Mayor's Real Estate Advisory Task Force

Report and Analysis

Proposed Rewrite

TITLE 21

Figure 1

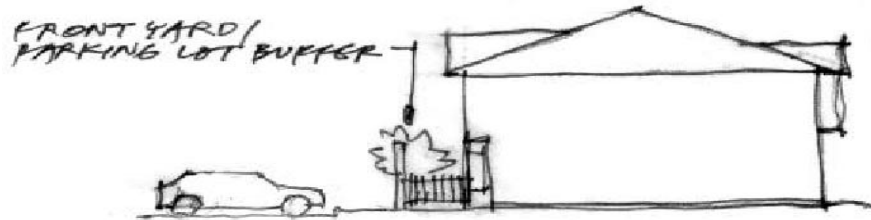
- Require some spatial and landscape buffer between a unit's front door and parking lot/drive, where parking is in a lot (no garage). Figure 1

Figure 2

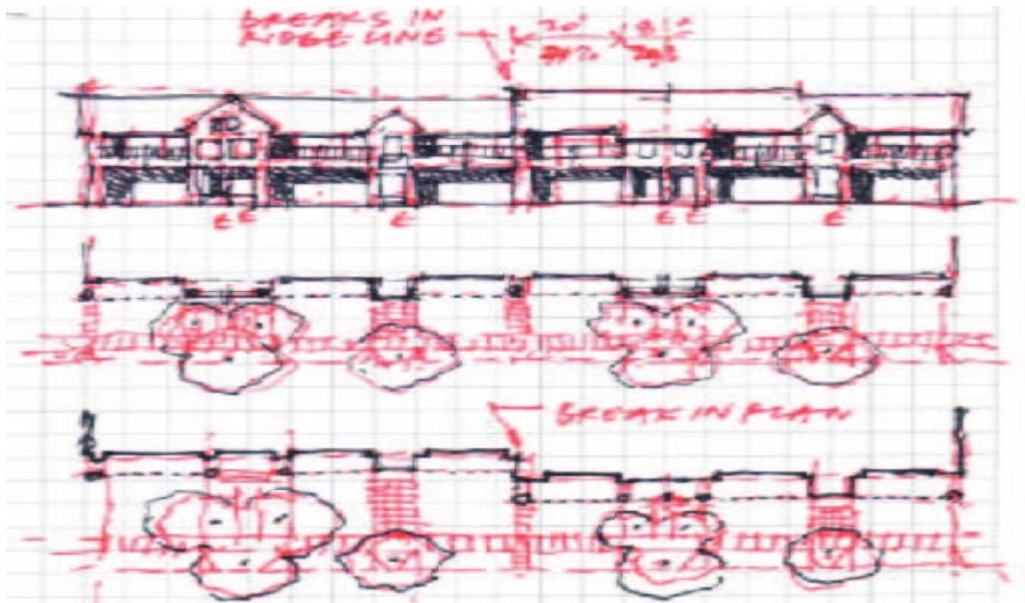
- Allow a landscaped buffer zone between the front door and a parking lot to count for some interior parking lot landscaping.
- Cluster entries between garage doors so as to form a larger porch, pedestrian/landscape zone between driveways. Figure 2

Figure 3a above, Figure 3b below

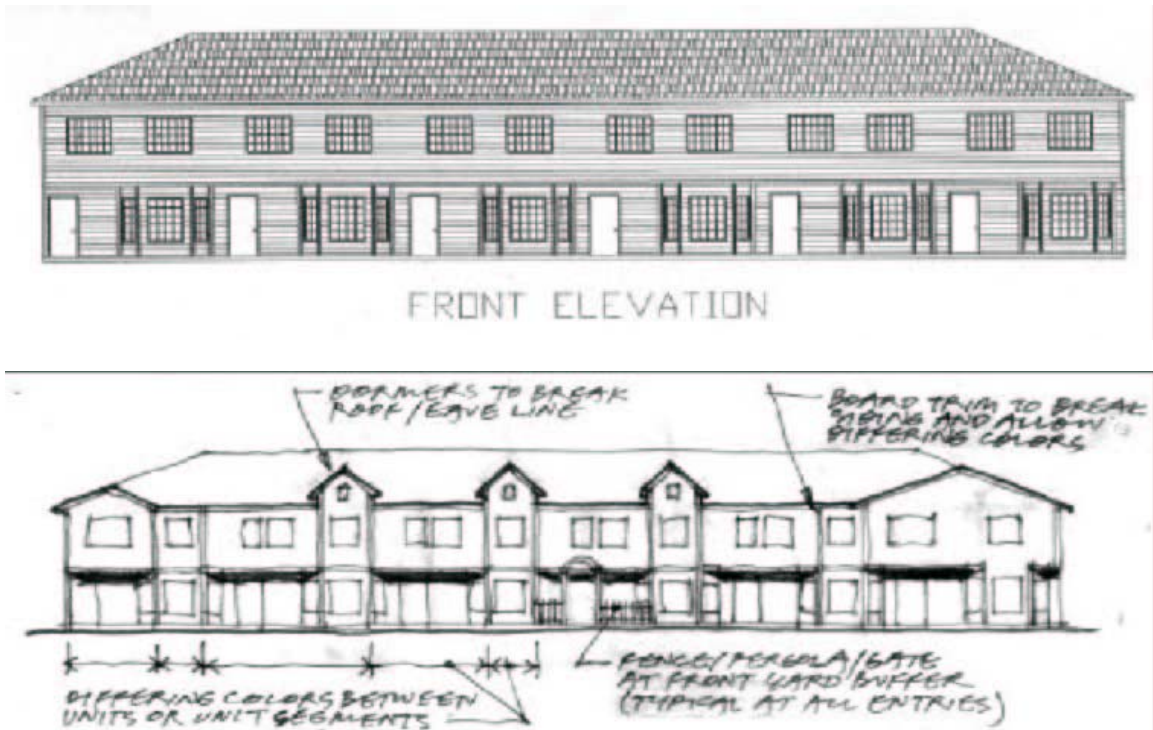
9. Require on-site snow storage, or possibly require a bond to allow the city to plow and remove and charge back the owner?
10. Require some variety between buildings in form, material and/or color. Add to the building variety menu list. Figure 3a and 3b.

Figure 4 a.

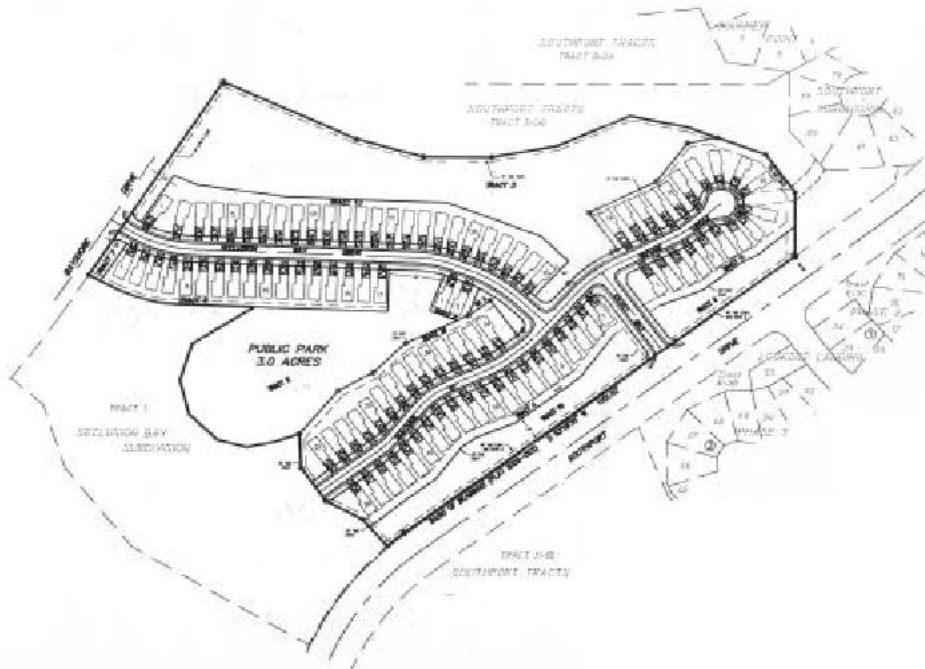
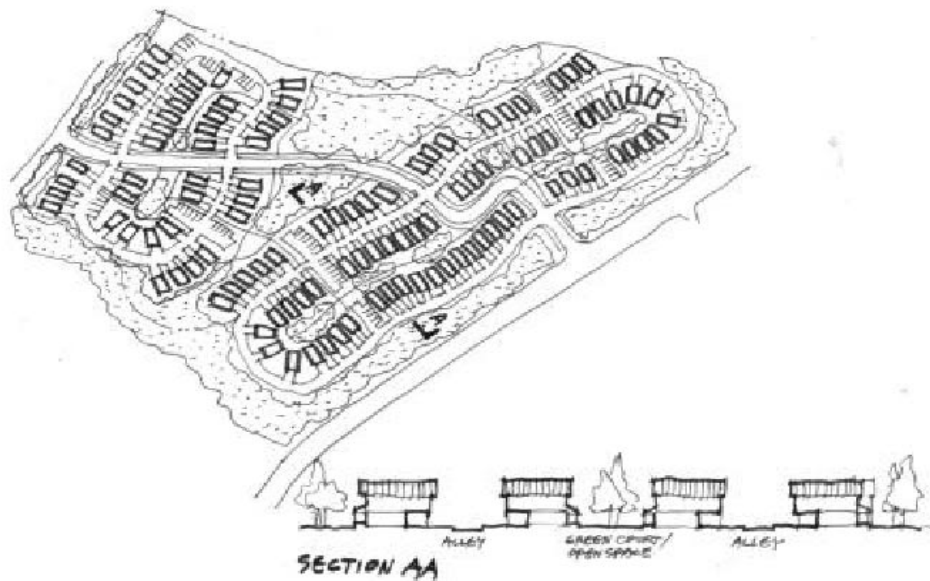
1. Mitigate impact of garage door by recessing it behind a porch-like extension in front of it, possibly with a balcony over the garage door and extend the front door access into this porch-like zone.
2. Create a garage door menu/front door menu with a least one choice from a short list of desired elements.
3. Provide incentive for alleys (so that garage doors are at the back of the house rather than the front) Figure 4 a. and 4 b.
 - allowing narrower streets
 - reducing front yard setbacks
 - not requiring or reducing private common open space
 - not requiring snow storage
 - allowing attached sidewalks or walking in the streets
 - green courts without streets in front, only alleys behind
 - not requiring tree canopy retention.

Figure 5

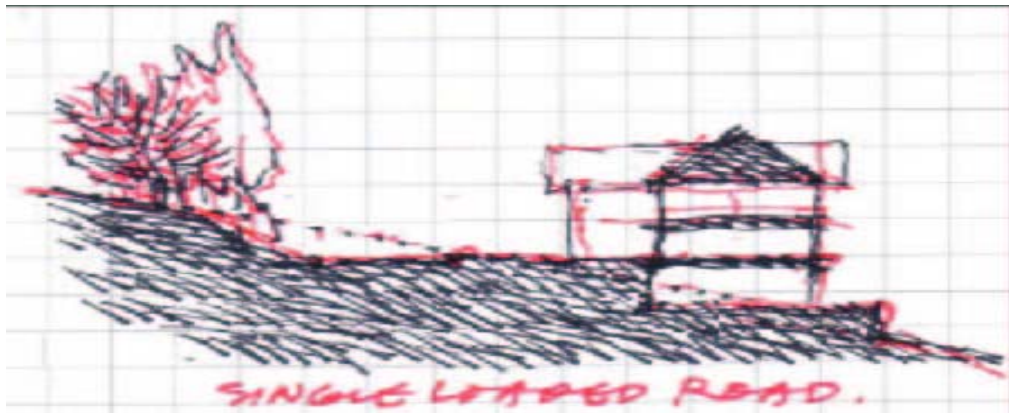
1. Increase height of retaining walls with possible new materials requirement.
2. Allow stepped retaining walls.
3. Develop a more-inclusive garage/garage door menu, such as:
 - third car garage door stepped back from first/second car door
 - garage doors under a balcony the full length of the door
 - painted doors
 - windows in doors
 - special paving patterns in driveways

- curb cut narrower than combined driveway.
4. Possibly relate garage door proportion to the entire area of the front facade, as well as to the length of the facade.
 5. Provide incentives for single loaded streets/lots on a slope or discourage lots that cut deeply back into the slope. Figure 5
 6. Reduce or eliminate private open space requirement.
 7. Reduce or eliminate tree canopy requirement or focus on specimen trees for retention.
